From: Cook, Pat (DEQ)
Sent: Monday, October 05, 2015 8:31 AM
To: Benzie, Richard (DEQ)
Subject: RE: Flint schematic in OEL

From: Crooks, Jennifer [<mailto:crooks.jennifer@epa.gov>]
Sent: Friday, October 02, 2015 12:46 PM
To: Busch, Stephen (DEQ); Prysby, Mike (DEQ); Rosenthal, Adam (DEQ); Benzie, Richard (DEQ)
Cc: Poy, Thomas
Subject: Flint schematic in OEL

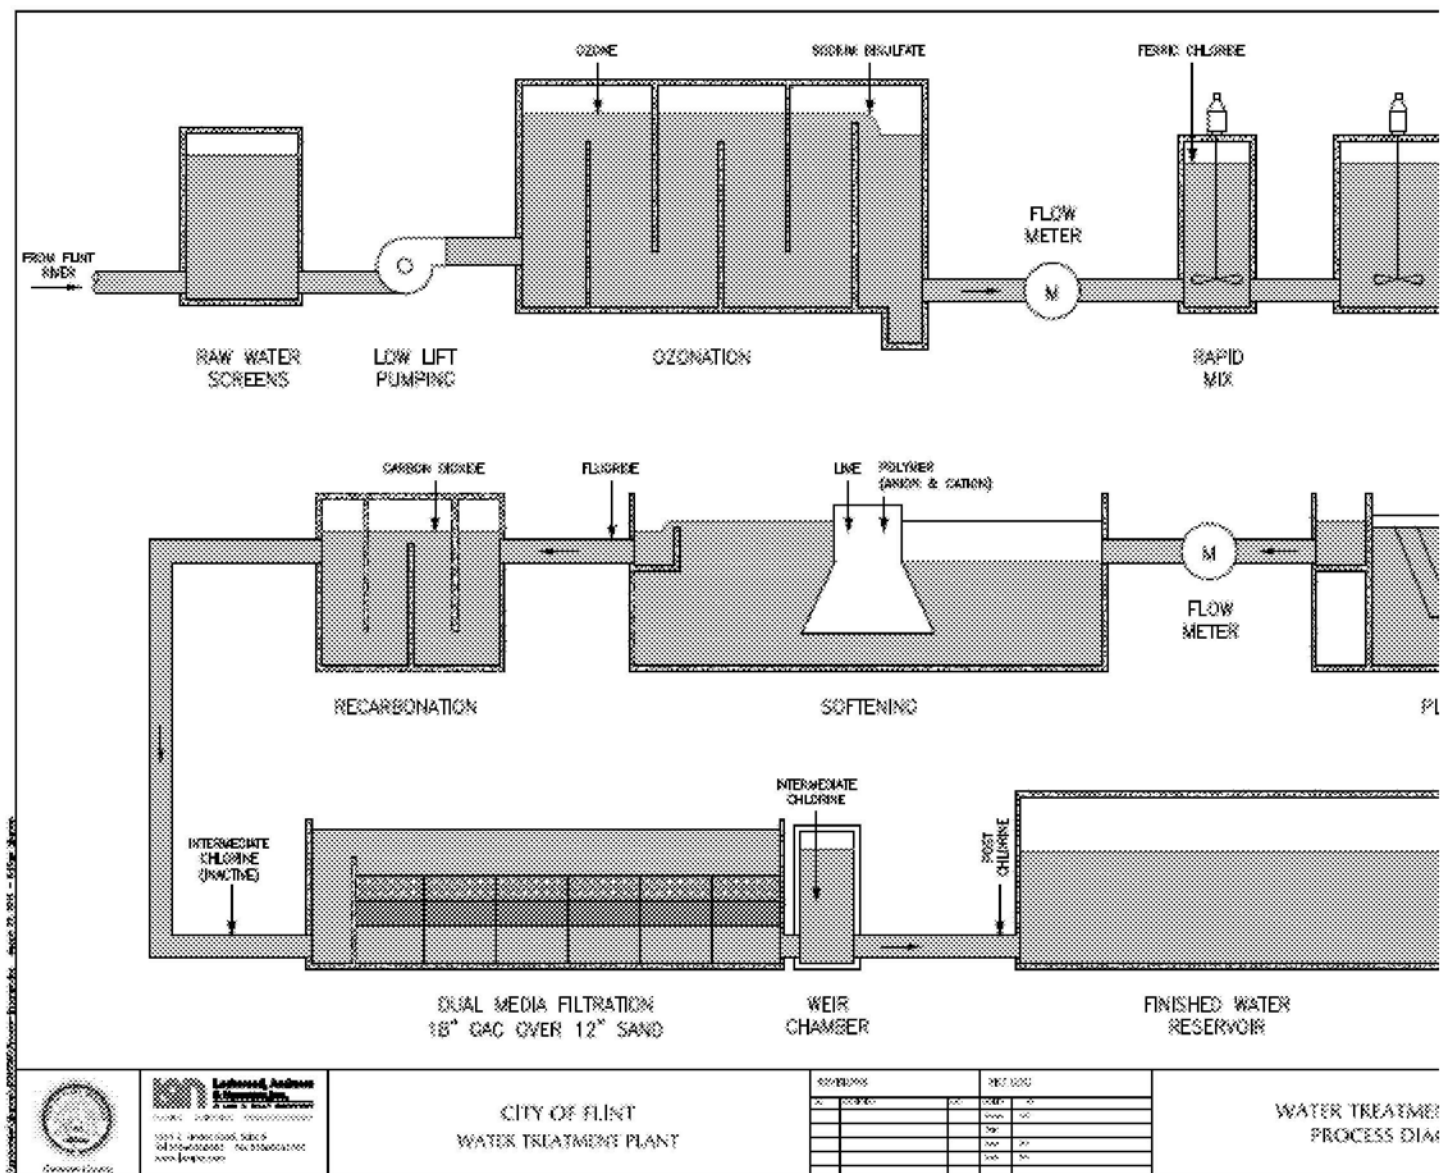
Have we routinely allowed filter plants to have only 12-inches of sand in there dual-media filters?

We have allowed it from time to time and in Flint's situation I believe it was allowed based on a quick and dirty pilot study.
